DUKE POWER COMPANY

Re: Catawba Nuclear Station, Units 1 and 2  
Docket Nos. 50-413 and 50-414

Please find enclosed the proposed Catawba Units 1 and 2 Technical Specifications. These proposed Technical Specifications are in the form of marked-up Catawba Unit 1 Technical Specifications.

Figure 1 Catawba Unit 2 Reactor Coolant System Heatup Limitations Applicable up to 16 EFPY

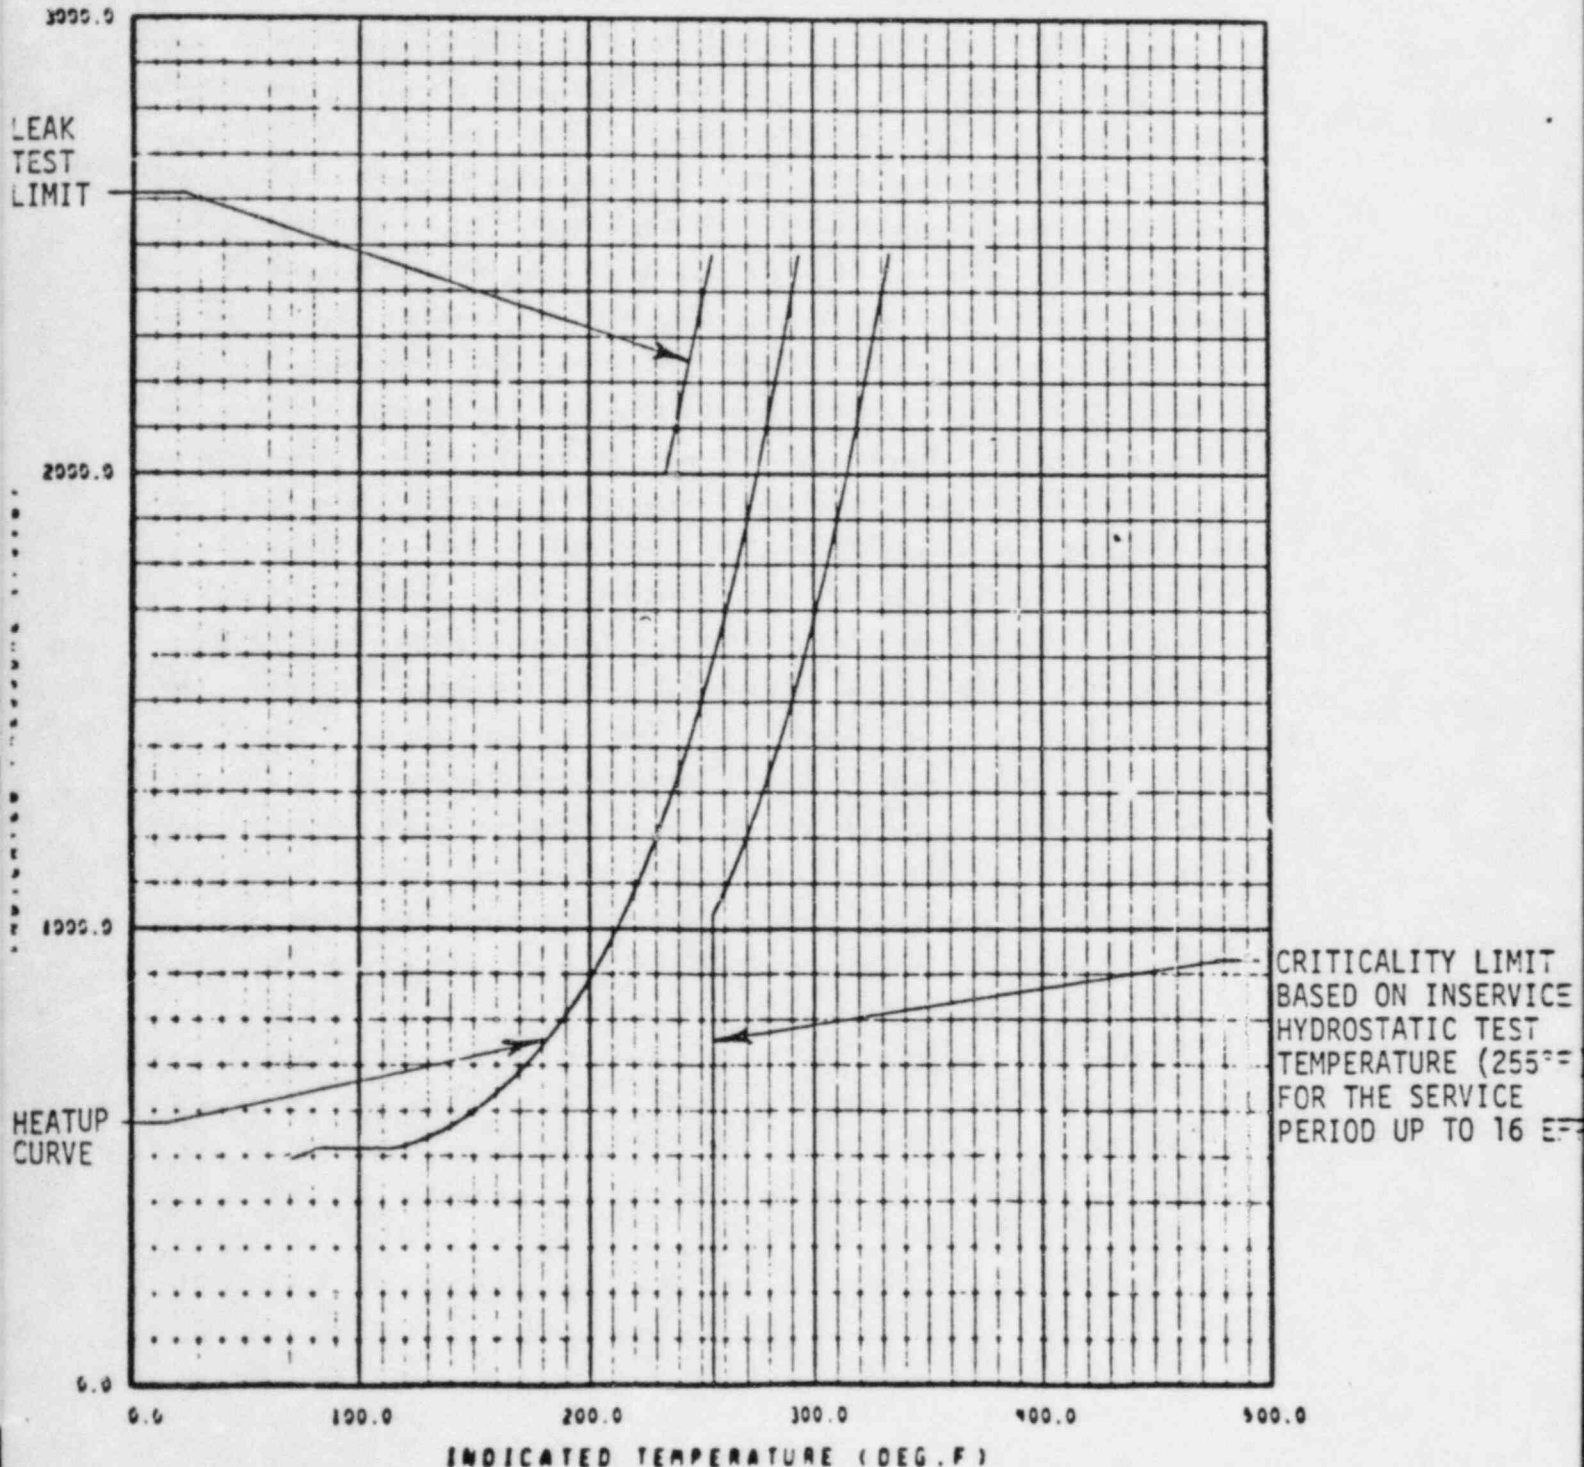
CURVE APPLICABLE FOR HEATUP RATES UP TO 60°F/HR FOR THE SERVICE PERIOD UP TO 16 EFPY AND CONTAINS MARGINS OF 10°F AND 60 PSIG FOR POSSIBLE INSTRUMENT ERRORS

Figure 2 Catawba Unit 2 Reactor Coolant System Cooldown Limitations Applicable up to 16 EFPY

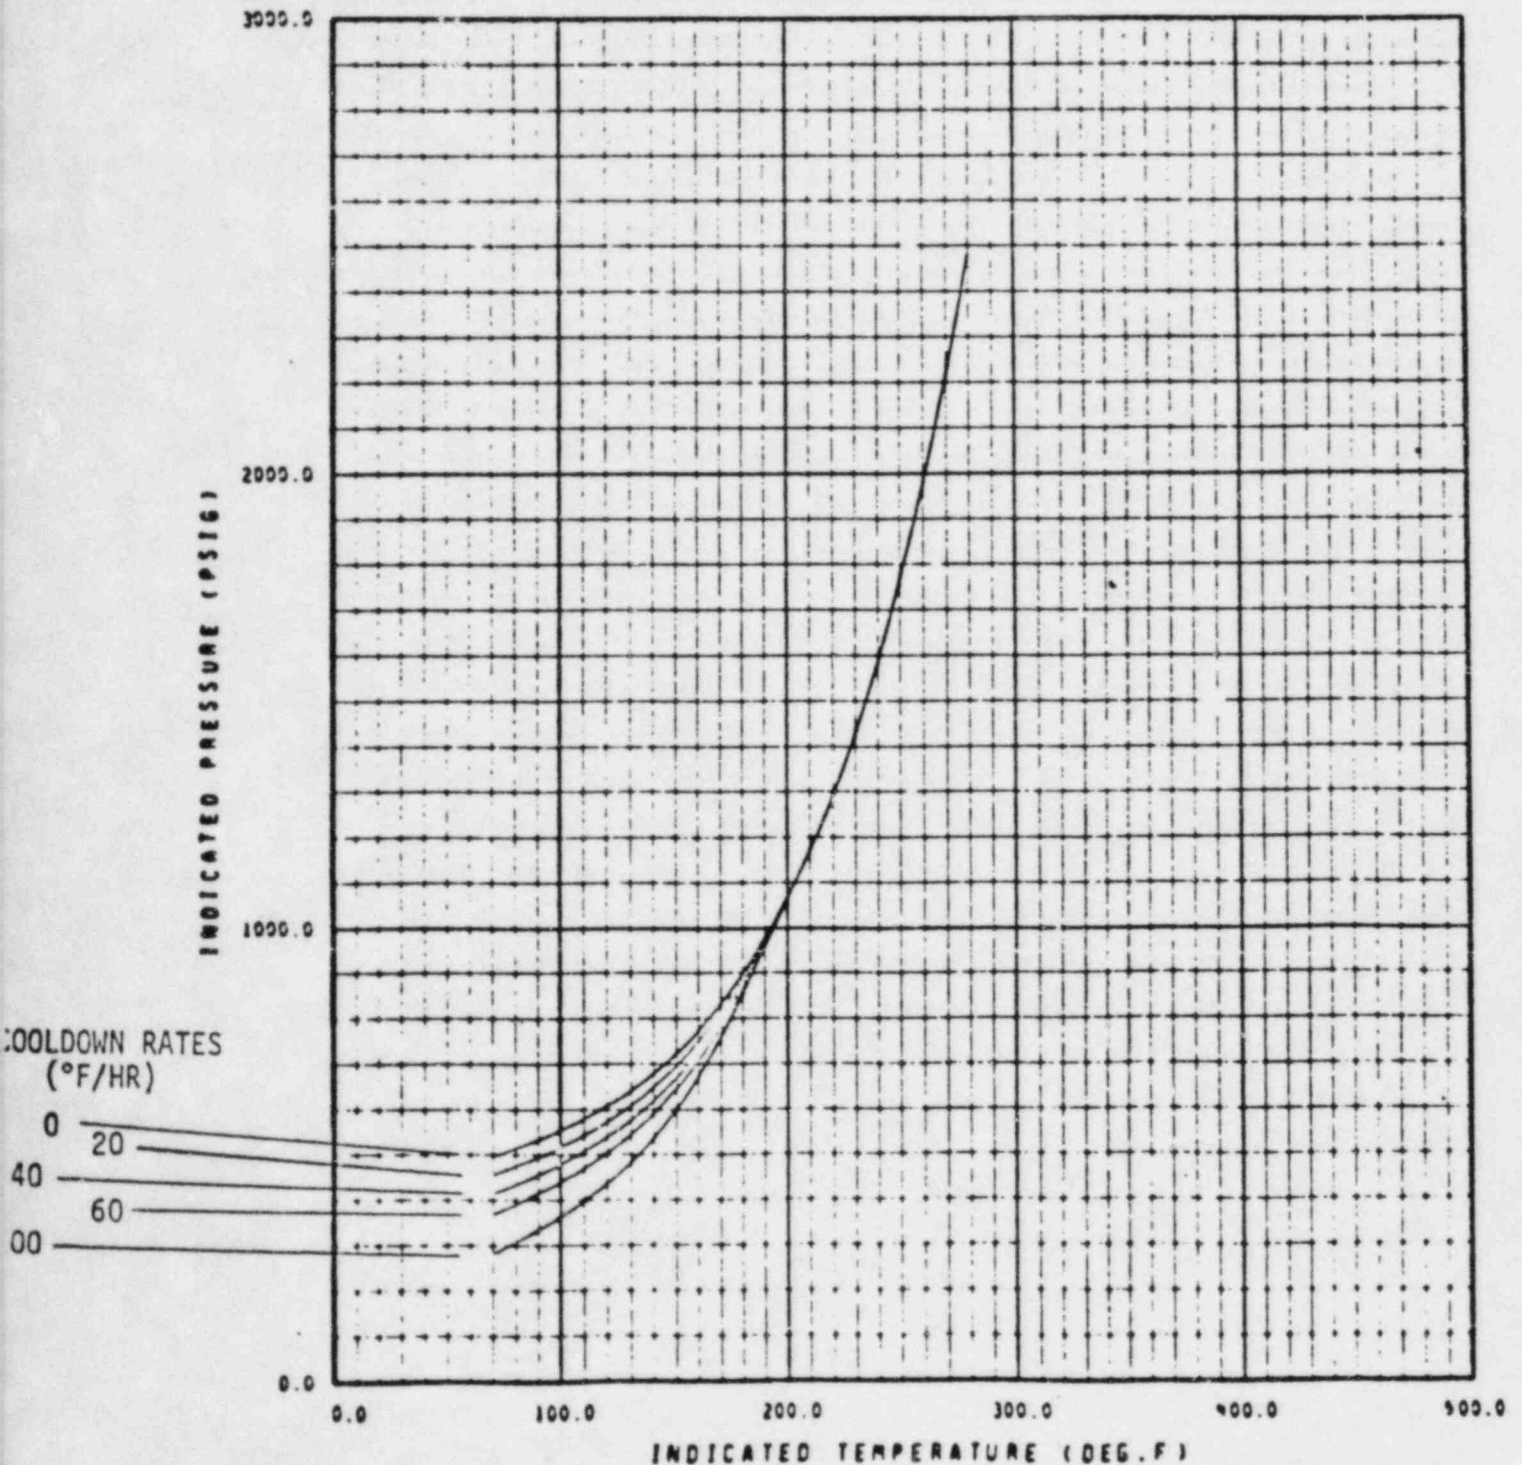
CURVE APPLICABLE FOR COOLDOWN RATES UP TO 100°F/HR FOR THE SERVICE PERIOD UP TO 16 EFPY AND CONTAINS MARGINS OF 10°F AND 60 PSIG FOR POSSIBLE INSTRUMENT ERRORS

FIGURE 4.7-1  
 SAMPLE PLAN 2) FOR SNUBBER FUNCTIONAL TEST

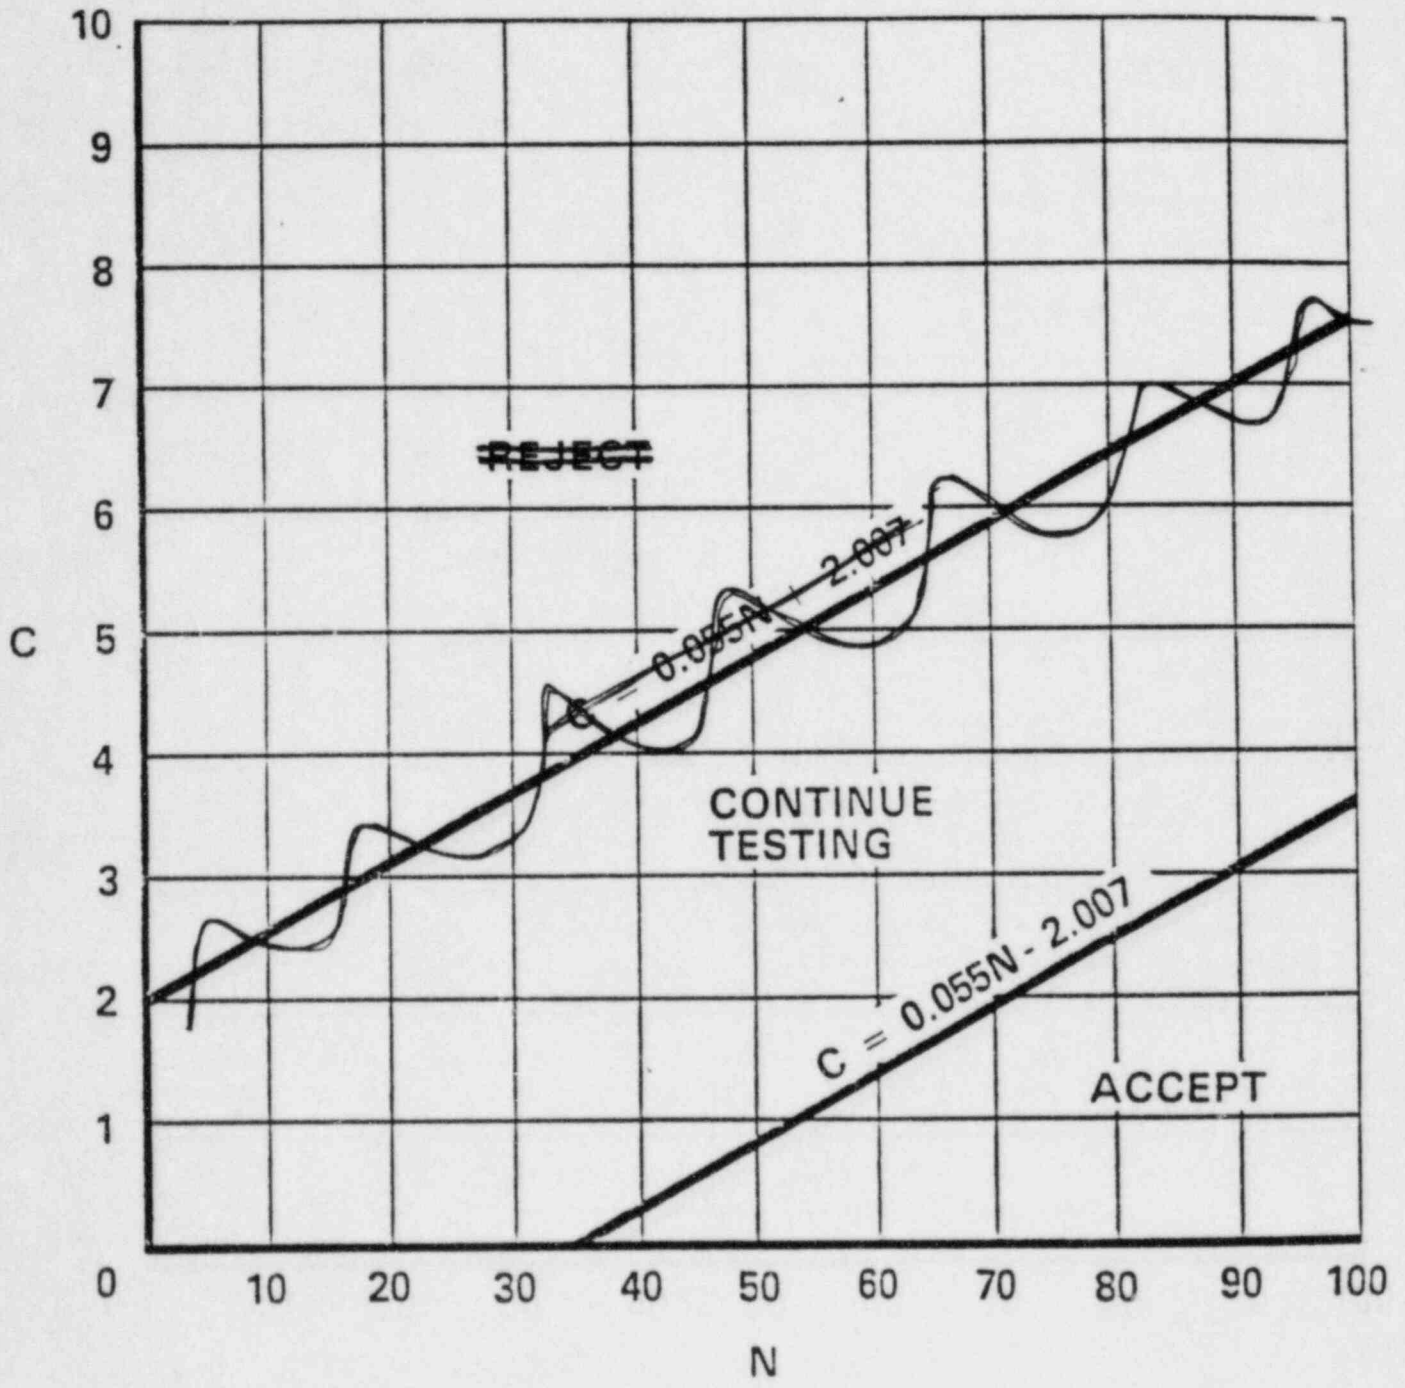
- 2) ~~A representative sample of all snubbers shall be functionally tested in accordance with Figure 4.7-1. "C" is the total number of snubbers of a type found not meeting the acceptance requirements of Specification 4.7.8f. The cumulative number of snubbers tested is denoted by "N". At the end of each day's testing, the new values of "N" and "C" (previous day's total plus current day's increments) shall be plotted on Figure 4.7-1. If at any time the point plotted falls in the "Reject" region, all snubbers of that type shall be functionally tested. If at any time the point plotted falls in the "Accept" region, testing of snubbers of that type may be terminated. When the point plotted lies in the "Continue Testing" region, additional snubbers of that type shall be tested until the point falls in the "Accept" region or the "Reject" region, or all the snubbers of that type have been tested; or~~

- 2) A representative sample of all snubbers shall be functionally tested in accordance with Figure 4.7-1. "C" is the total number of snubbers found not meeting the acceptance requirements of Specification 4.7.8F (failures). The cumulative number of snubbers tested is denoted by "N". Test results shall be plotted sequentially in the order of sample assignment (i.e. each snubber shall be plotted by its order in the random sample assignment not by the order of testing). If at any time the point plotted falls in the "Accept" region, testing may be terminated. When the point plotted lies in the "Continue Testing" region, additional snubbers shall be tested until the point falls in the "Accept" region or until all snubbers have been tested.\*
